**National TAB  
1329 E. KEMPER ROAD  
SUITE 4210  
CINCINNATI, OH 45246**

**Report: FINAL TAB REPORT  
Function: Test, Adjust, & Balance  
Date: 10/11/2022**

## **10-03 FREDDY'S HAMPTON, VA**

**Issue Name :** HIGH PRIORITY - RTU-1 Economizer not functional

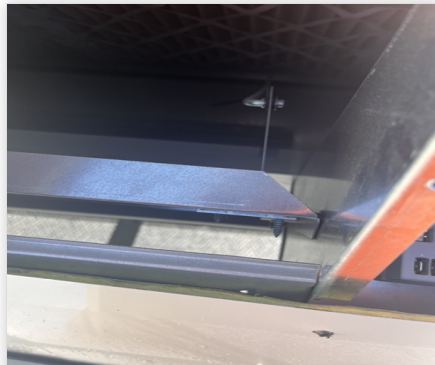
**Description :** Unable to set RTU-1 damper position despite the economizer receiving power. Tried moving damper to closed position the damper did not move.

- **10/11/2022 National TAB - Will Turnbough**
  - Airflow is 1671 CFM out of 900 CFM. Mechanical contractor unable to adjust damper either. Recommend mechanical contractor contact the manufacturer to troubleshoot and resolve.

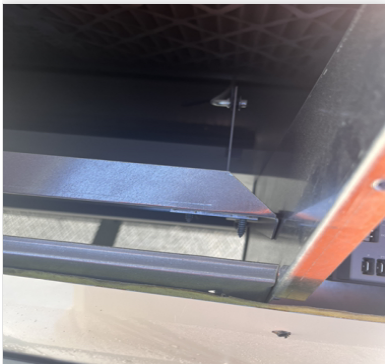
**Issue Name :** HIGH PRIORITY - RTU-1 Low flow  
**Description :** RTU-1 total flow is about 80% of design. Motor sheave is already at 1 turn out (B belt).  
**Created By :** National TAB **Assigned To :** National TAB - Will Turnbough  
**Status :** Open  
**Originated Date :** 10/05/2022 - David Annan - National TAB

- **10/11/2022 National TAB - Will Turnbough**
  - There is enough amperage on the motor to change pulleys and increase airflow closer to design. But further evaluation of the supply and return ductwork is required first.
- **10/11/2022 National TAB - Will Turnbough**
  - Discharge pressure on the supply side is high indicating restriction. To achieve design airflow requires 1.4" of discharge pressure which is very high. Ductwork is shown on plans as (2) 18" runs which is a 3.5 free area. Requires a velocity of 1430 FPM which is slightly high. Further investigation of the supply ductwork and connection to unit is required.
- **10/06/2022 National TAB - David Annan**
  - Return damper looks slightly restrictive. More investigation needed.

**Issue Name :** LOW PRIORITY - RTU-1 Condensate is not installed-W.I.P

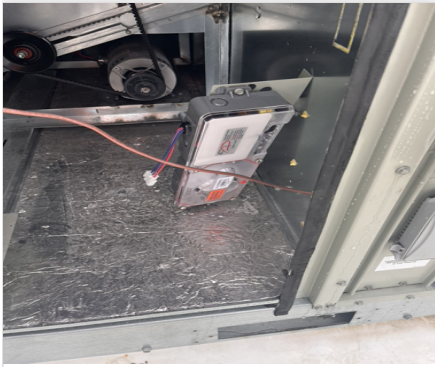
**Description :** RTU-1 condensate line is not installed .
